The 4302 7th Avenue NE site is located in the vibrant University District NW Urban Center Village. It is predominantly populated by students and faculty of the University of Washington. The project team seeks to design a 4 story above grade 47-unit multi-family apartment building with 11 below grade parking spaces.

At the Third Early Design Guidance Meeting, the Board suggested locating the south interior exit stair door off the “patio”. The stair will probably be heavily used as circulation by the many of the tenants. See Guideline A-4.

SITE PLAN
 0 2' 4' 8' 16'
 SCALE IN FEET

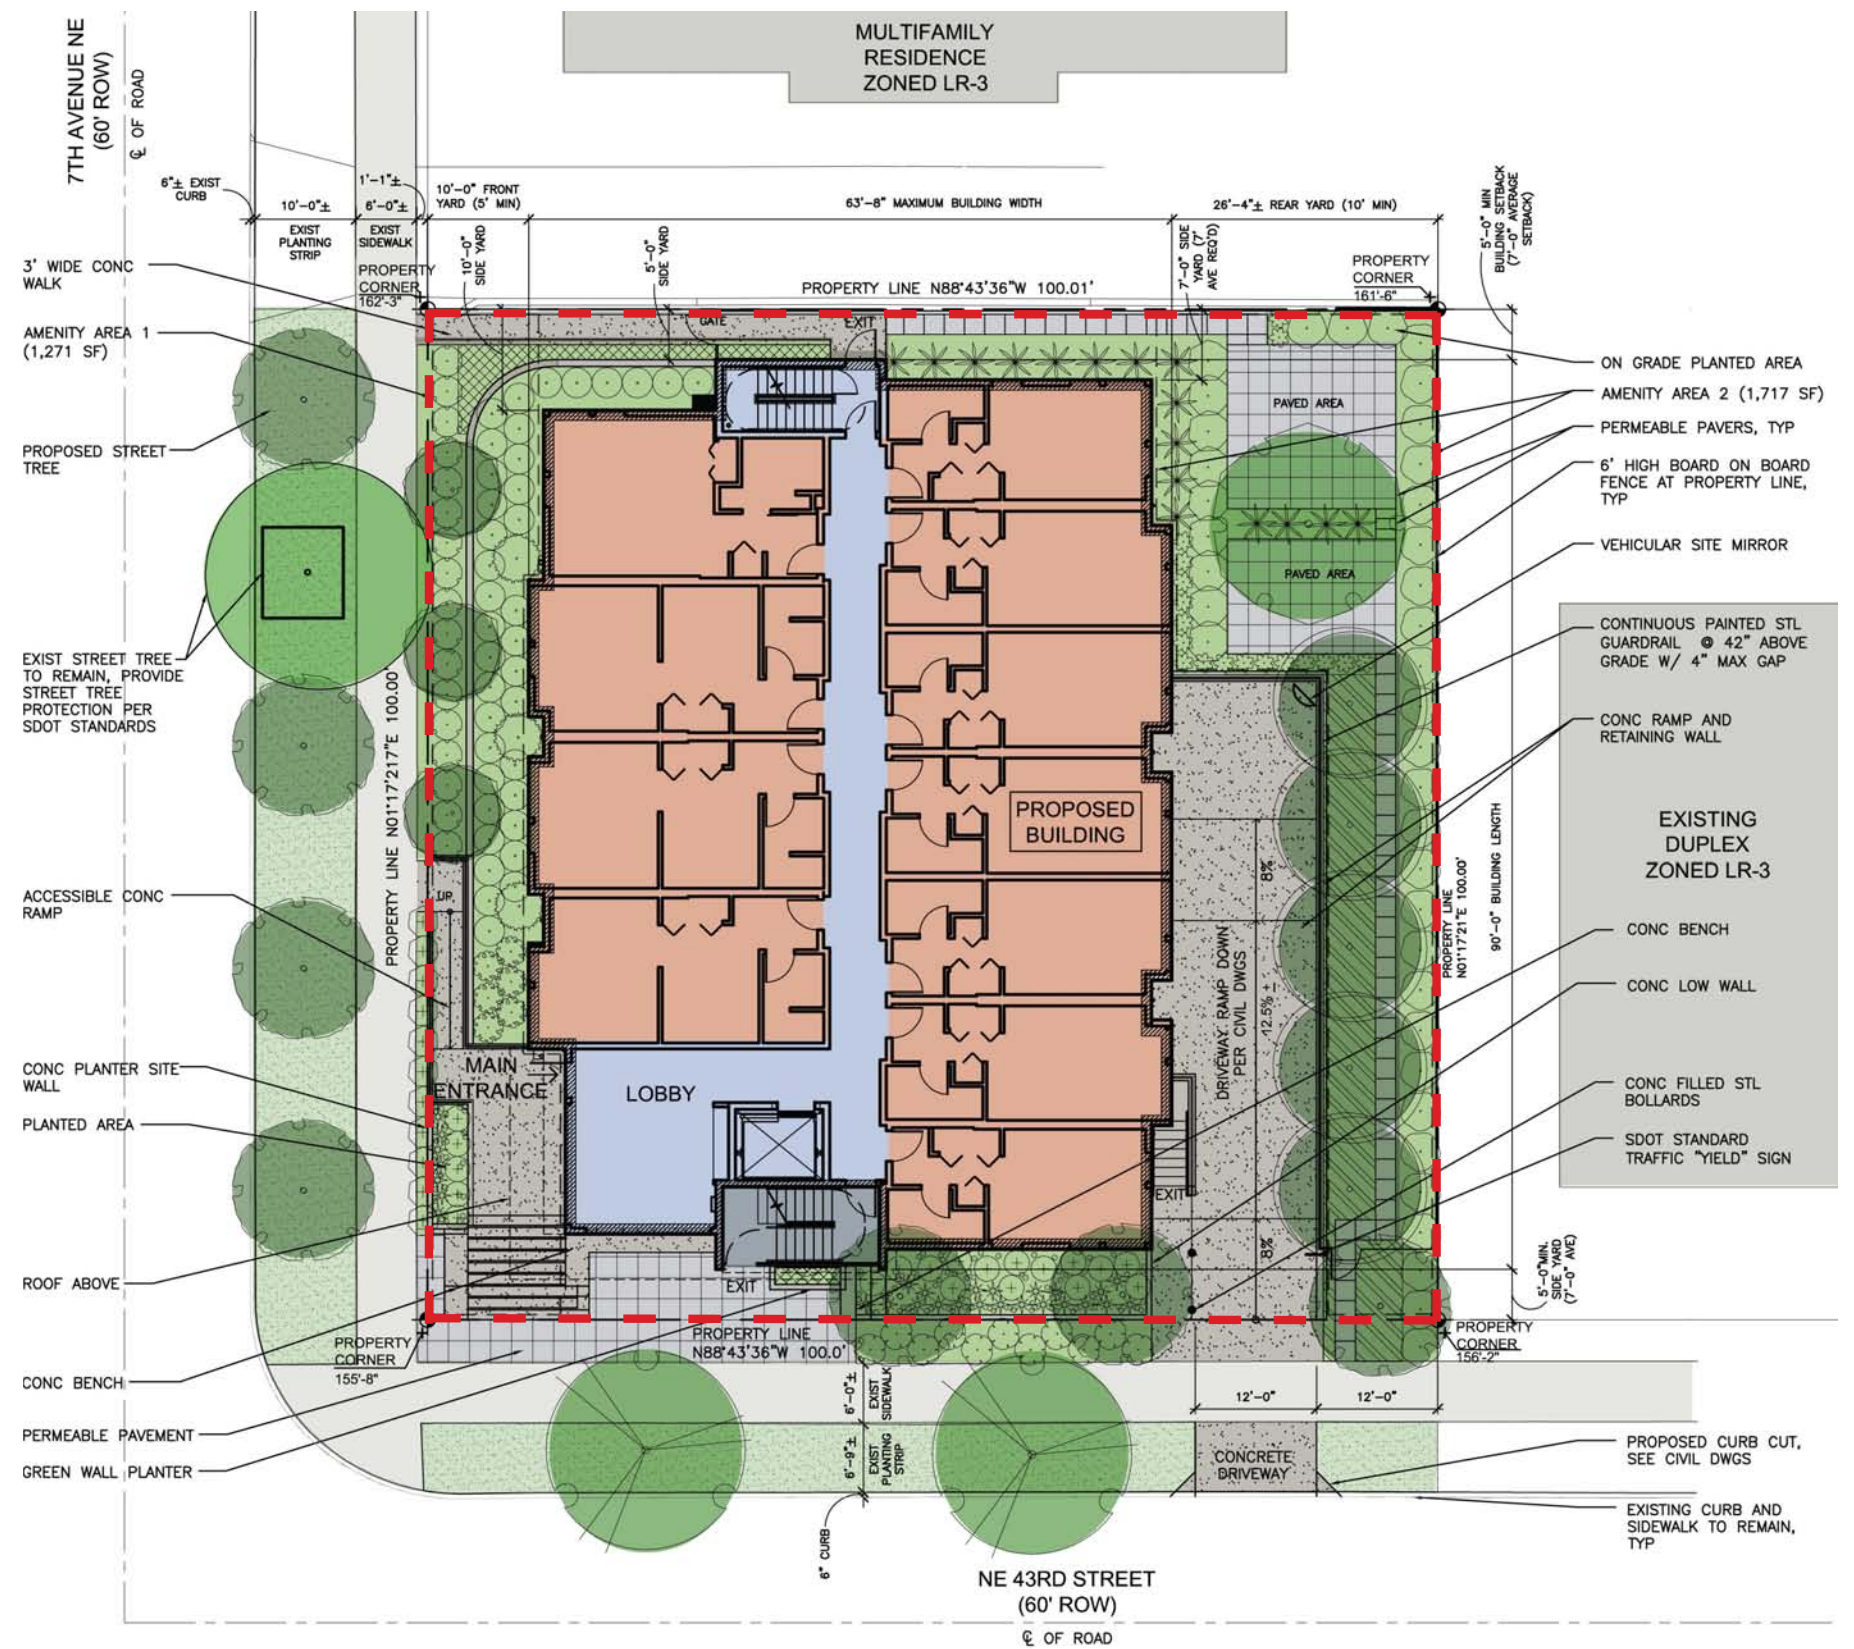
At the Third Early Design Guidance Meeting, the Board noted that the driveway width should be the minimum needed at the intersection with the sidewalk and street. Sight triangles and other measure should be shown that will provide for pedestrian safety

Response: The single driveway is a minimum 12 feet at the intersection with the sidewalk and street. Sight triangles are shown on the Site Plan and meet code standards.

LANDSCAPE PLAN

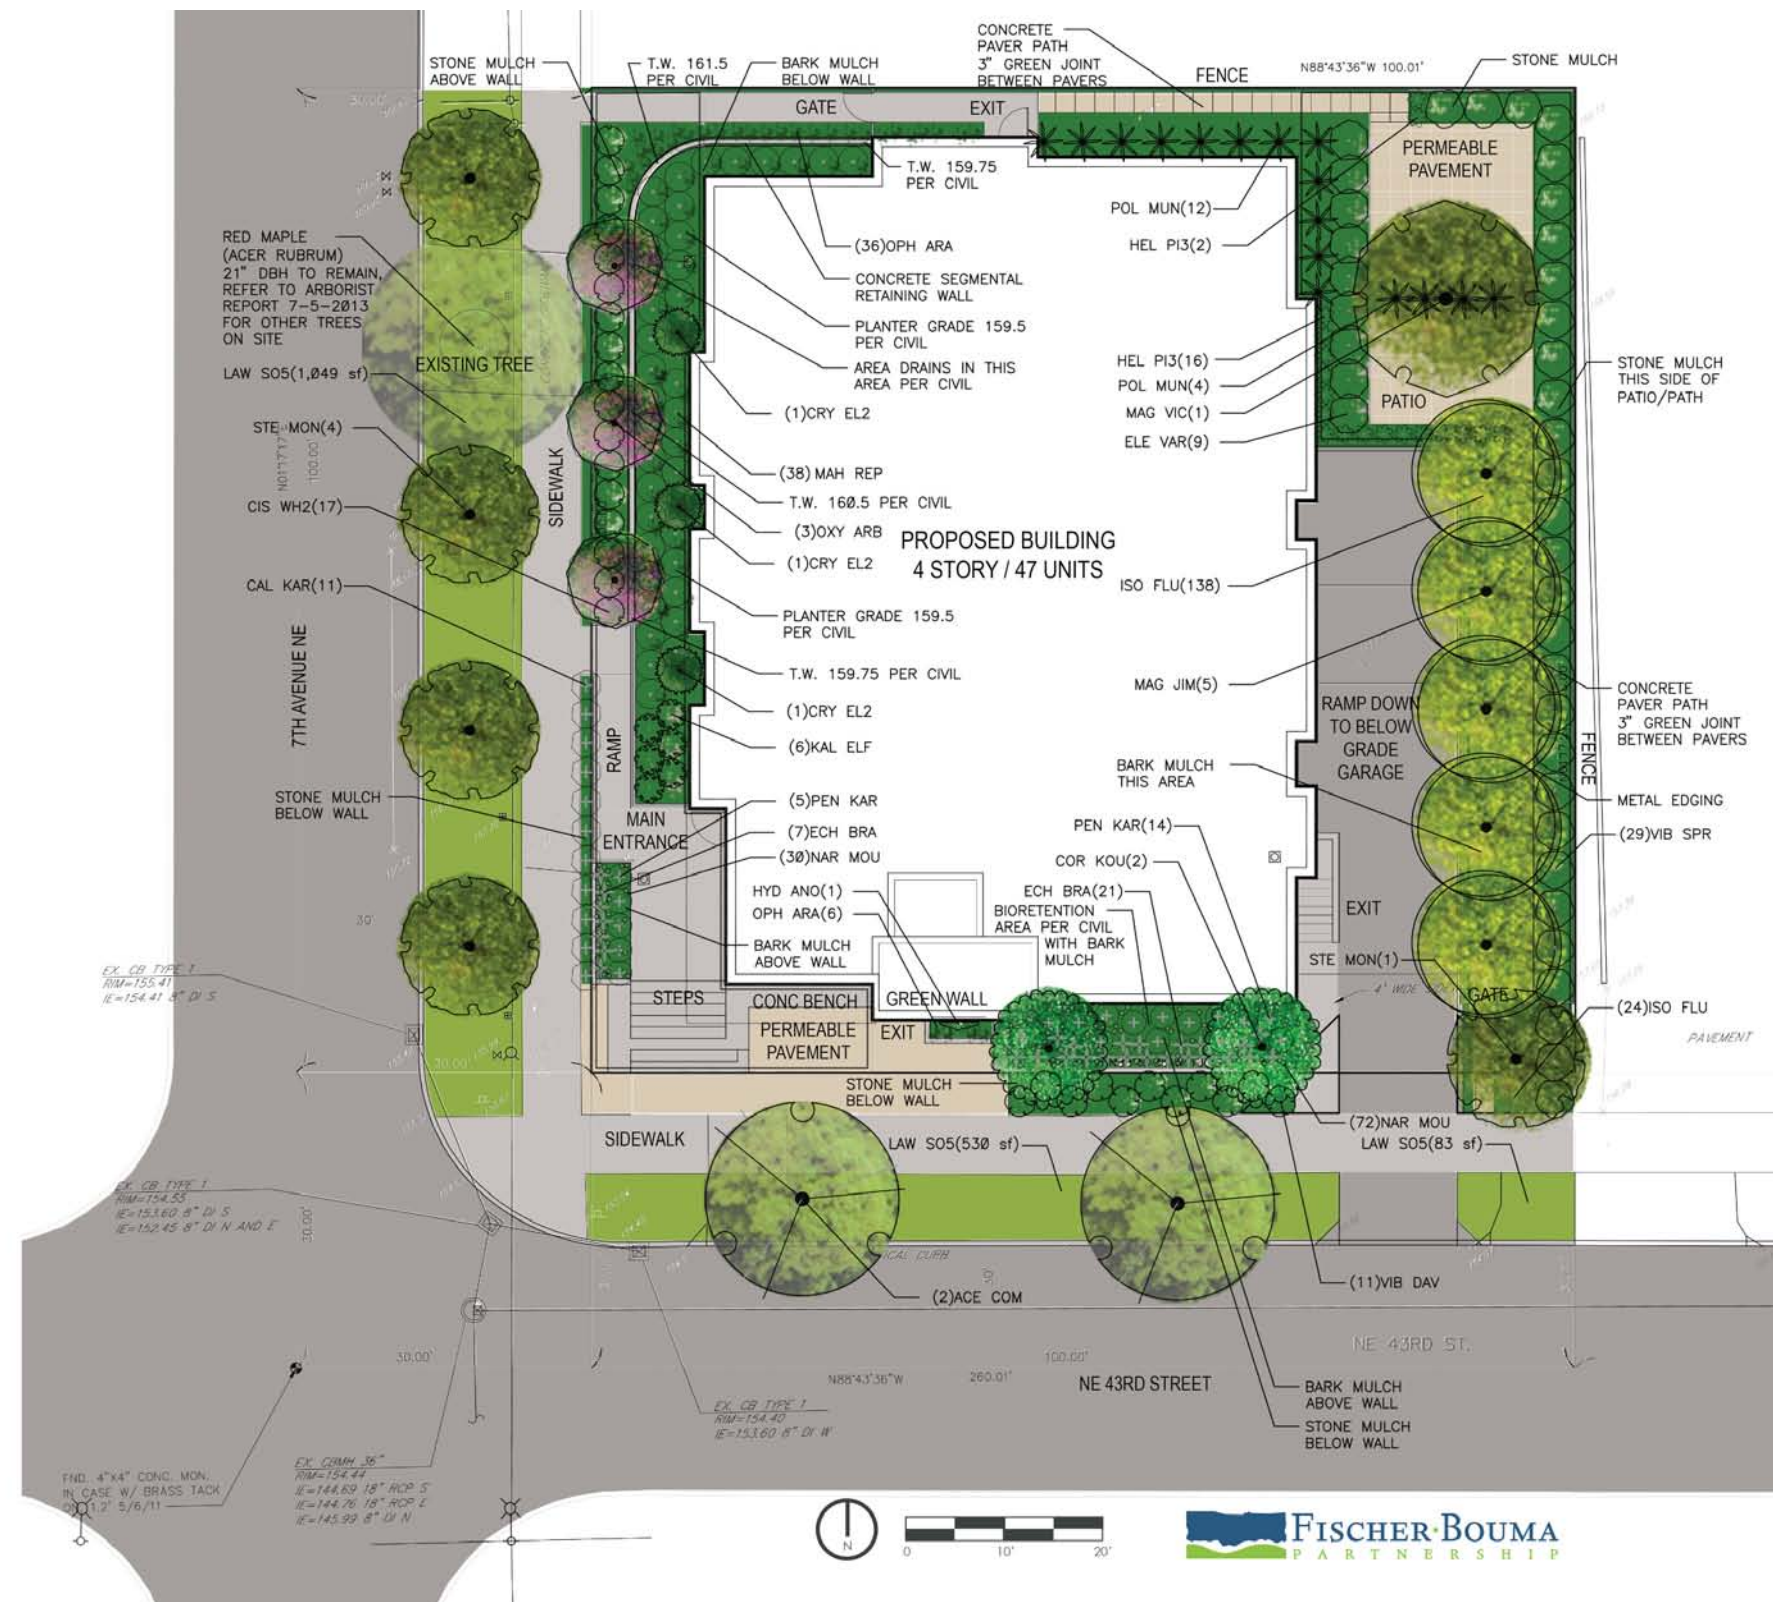
At the Third Early Design Guidance Meeting, the Board indicated this guideline as a highest priority. Provide a detailed landscape plan at the Recommendation meeting.

Response: The landscaping has been revised to incorporate these items and concerns. Varied plant material and sizes as well as hard-scapes add to the interest of the site. A four story vertical green wall at the south staircase will be highly visible and creates a focal point for the project.
